Response by Michael Brown to Action Point no. 2 from Open Floor Hearing 1.

The map of the Central Site with this note is based on figure 17.5 ‘Public Rights of Way and Other Promoted Routes’ (APP-112) onto which have been marked in pink, viewpoints with photomontages, and in green viewpoints without photomontages both taken from figure 8.10 ‘Representative Viewpoints and Photomontage Locations’ (APP-085).

Client PVDP
Project Botley West Solar Farm
Title Public Rights of Way and Other Promoted Routes
Status FINAL
Drawing Number EN010147/APP/6.4
Figure Number 17.5
Drawn By JM
Scale @ A3 1:25,000
Date Created NOV 2024
PM/Checked By CL
Date Created NOV 2024

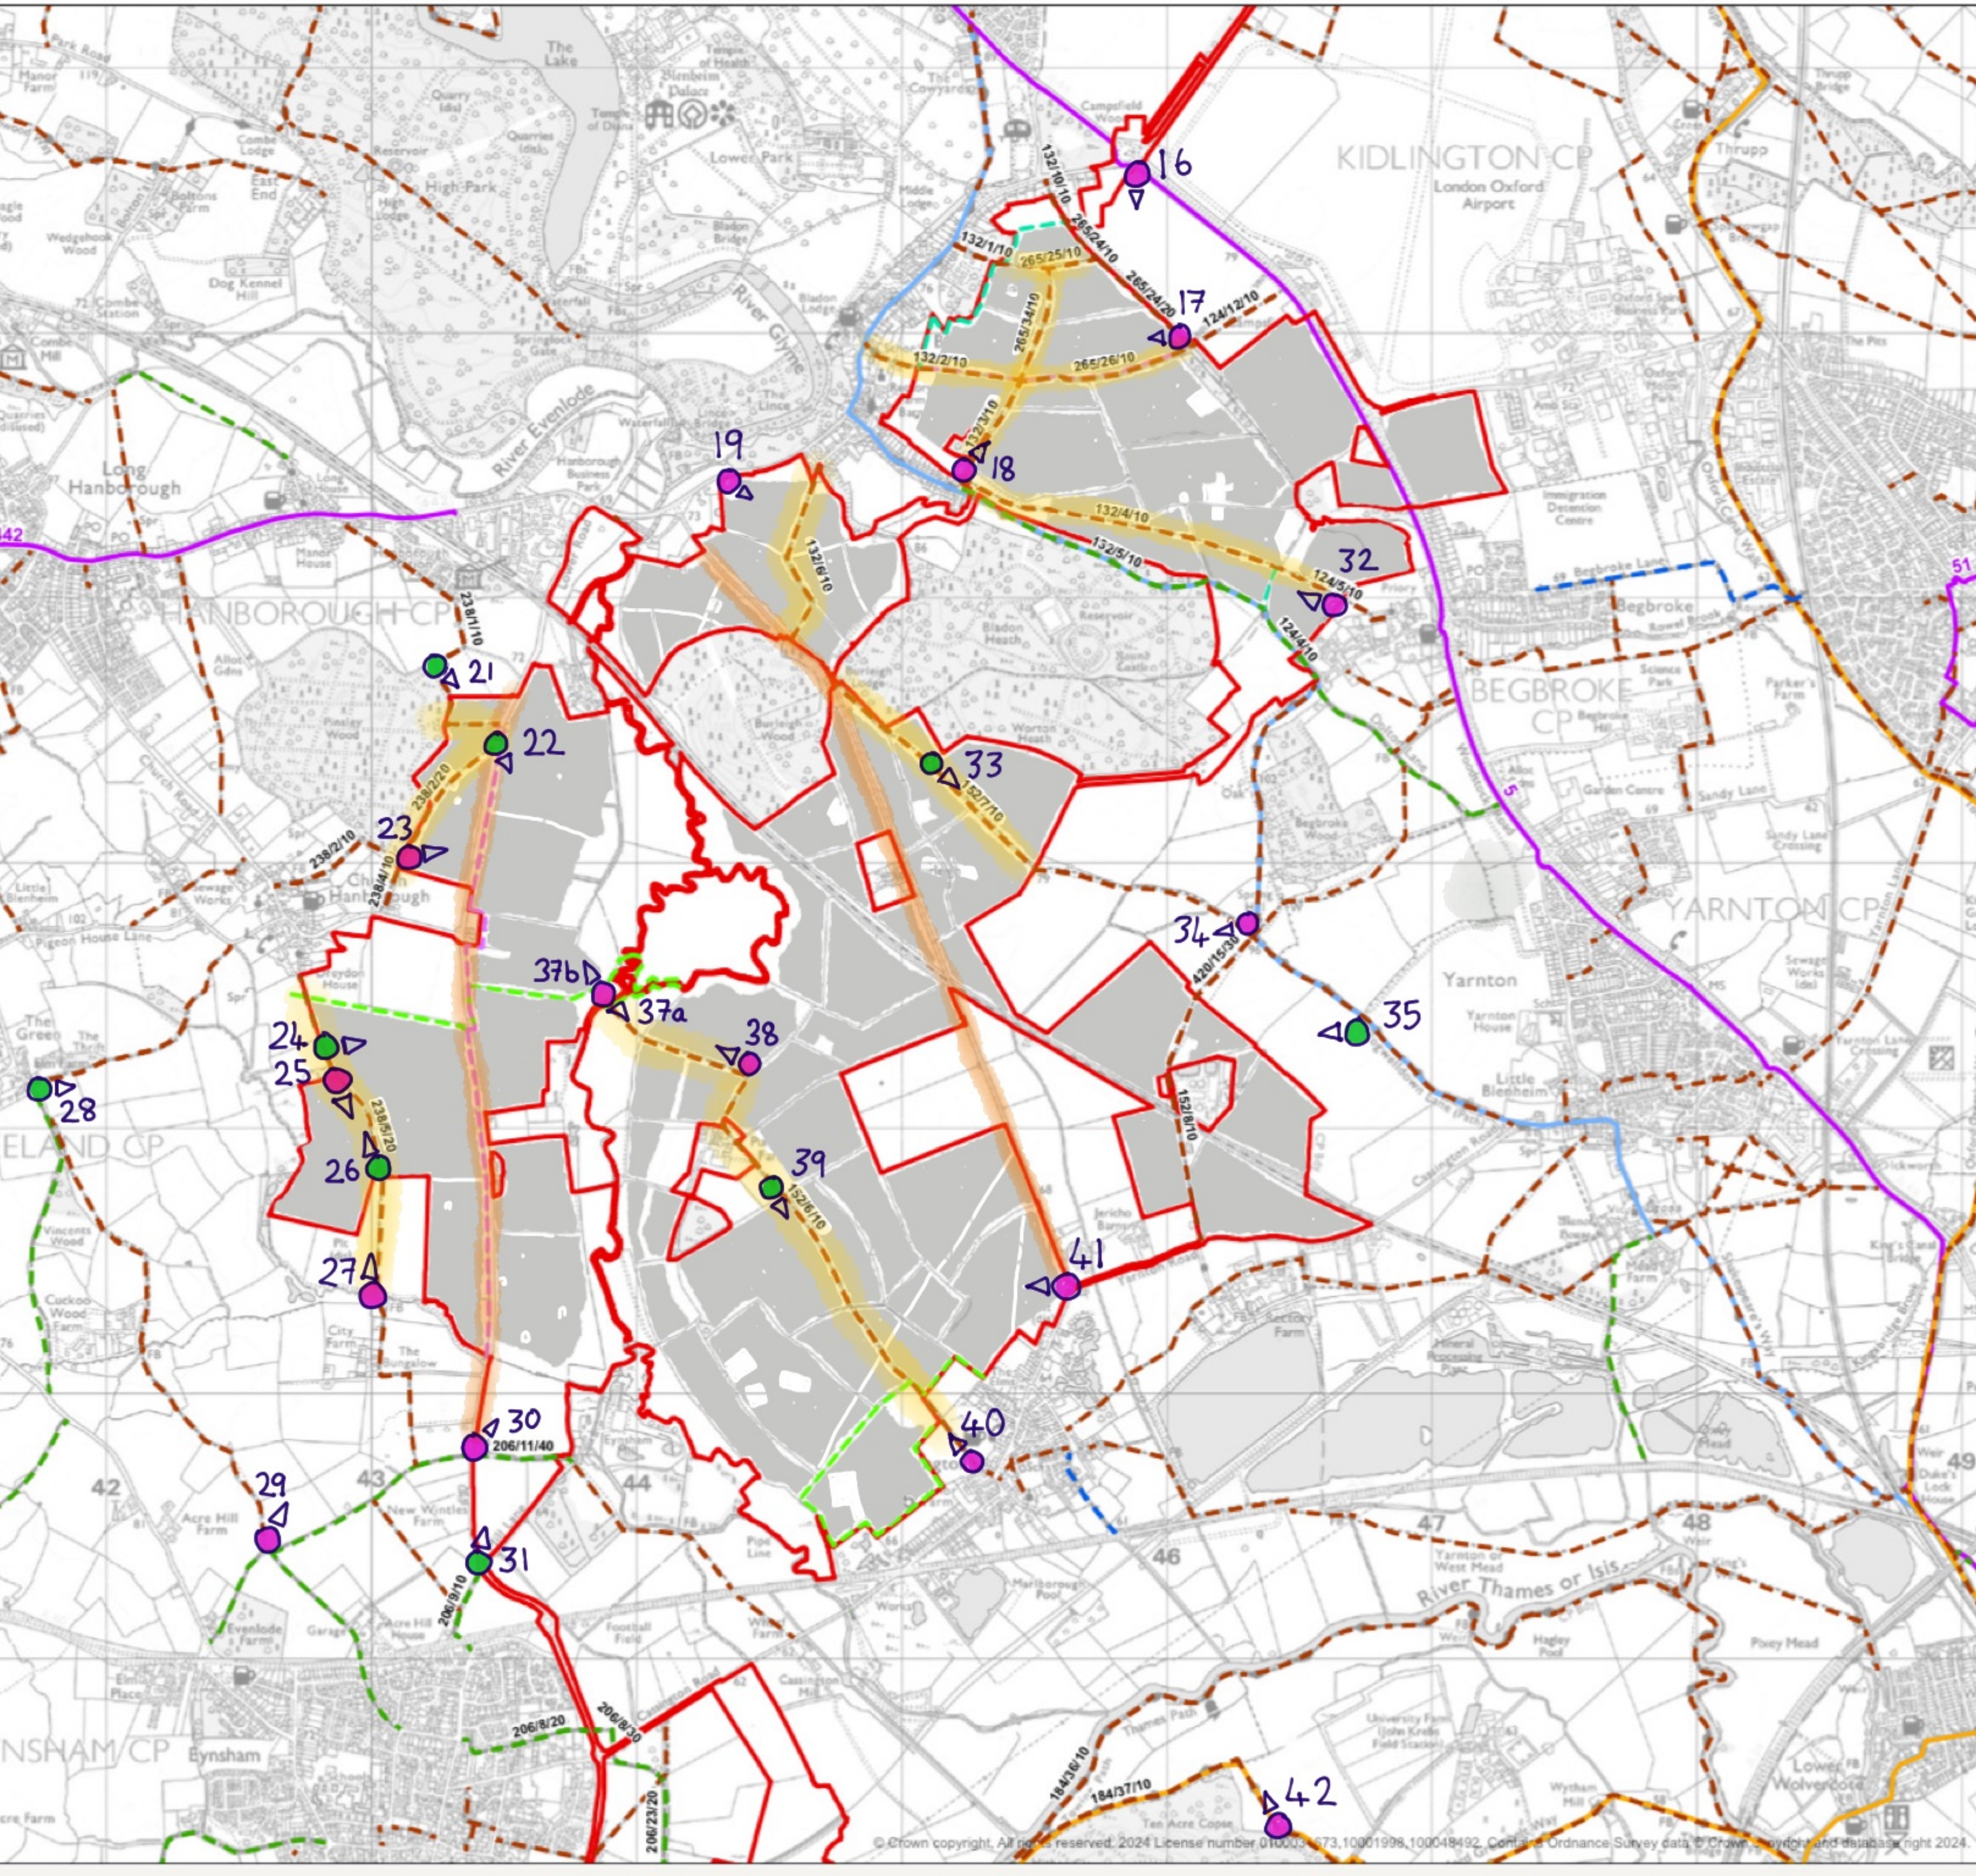
Examples of inadequate assessments, and factors leading to significant under assessments in the LVIA in the ES Chapter 8 (APP-045 for the Central site – paragraphs 8.9.178 – 8.9.231), include:

1. The limitation of viewpoints to 55 has inevitably provided only sparse coverage for such a huge triple site project proposed over undulating countryside. For example:

- 2km footpath 124/12/10, 265/26/10, 132/2/18 only has one viewpoint, 17. The assessment for this viewpoint at paragraph 8.9.180 of APP-045 ignores this footpath but the inadequate or under assessment of the wide foreground view impact is still relevant.

- 2km footpath 132/4/10 only has one viewpoint, 32. Summer yr.15 assessment of ‘not significant’ is much understated.
 - 2.5km footpath 132/6/19 and 152/7/10 within the Site’s red line limits has only one viewpoint, 33. This viewpoint has not been montaged and is not representative of this footpath which would have many more seriously impacted locations in years 1 and 15.

- 3.5km of Lower Road has no viewpoints between 22 and 30, and 4.5 km of Burleigh Road has only one viewpoint 41 at the southern end.

2. The failure to provide photomontages for all current viewpoints, in particular: 21, 22, 24, 26, 33, 37a and 39 in the central site has exacerbated the problem. Viewpoint 24 for example provides a major view across the Evenlode valley. (APP-065, Fig. 8.178 summer and APP-066, Fig. 8.62 winter). It will be seriously impacted by fencing and panels. It is not, as claimed, 'a glimpsed view' (APP-045 at paragraph 8.9.195) but a well-known and admired stopping point for the panoramic view across the valley.

5. No assessment of the 'within project' accumulation of adverse impacts along the whole length of: (a) each footpath or (b) the repetition of impacts on walkers along all the footpaths criss-crossing the site. The same applies to those travelling along Lower Road and Burleigh Road.

6. Lack of recognition of the extent of negative impact on heritage assets including conservation villages and listed buildings. For example: no viewpoints along 3.5km of Lower Road between viewpoints 22 and 30 despite many lengthy gaps in the hedging and at access points providing views up to Church Hanborough and its church steeple even in summer.

8. No genuine recognition of the continuous negative impact on walking by or between high metal fences and vast areas of panels. These are under assessed, for example at viewpoints 23, 32, and 38

9. No recognition of the strongly negative impact of corridors creating a 'tunnel' effect on walkers. For example: Yr. 15 viewpoints 32 and 38 (APP-077 and APP-078). Walking northeast from viewpoint 32 would be largely enclosed and towards a wall of panels ahead in the next field (APP-077, Figs. 8.824 - 7), and the panorama view from viewpoint 38 (APP-078, Fig. 8.338) towards Church Hanborough and its church spire would be ruined as shown by the photograph and corresponding photomontage both at Fig. 8.338.
